DEVELOPMENT REVIEW COMMITTEE (DRC) COMMENT REPORT

PROJECT NAME: ArchCo Metropolitan Signage

CASE NUMBER: R19053

REQUEST: Site Plan Level II Review: Downtown RAC

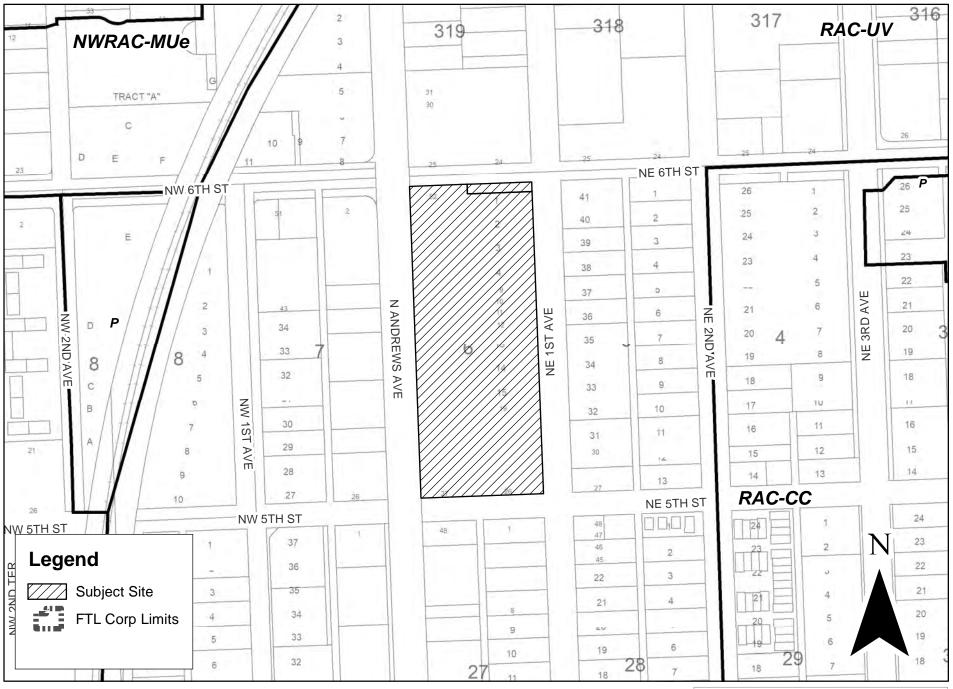
- 10) Provide a cross section of the building, including the building signage in the section.
- 11) The Site Plan Level II Downtown sign review process allows applicants to request signage that may not be permitted by right via existing code. While it is intended to provide more flexibility, signs should generally align with the vision for Downtown. The Downtown Master Plan establishes a vision for a dense, active urban core focused on a strong human-scale relationship to the public realm and promotes design principles that foster a more walkable downtown with street level activity and comfortable pedestrian paths, plazas and open space.

Oversized signs, numerous small signs, signs containing a clutter of letters or messages, all compete for the public's attention. Other common problems include quality of fabrication (materials such as plastic

or vinyl are not high-quality materials), poor selection of typefaces and colors, illumination options, and placement, style, and sizing that bear no relation to the adjacent building's architecture.

Sign types and materials have to be carefully selected to maintain durability and enhance the public realm throughout the Downtown. Respond to this comment by providing a written narrative outlining the design approach used for the proposed signs consistent with the Downtown Master Plan overall vision, as stated in the comment above.
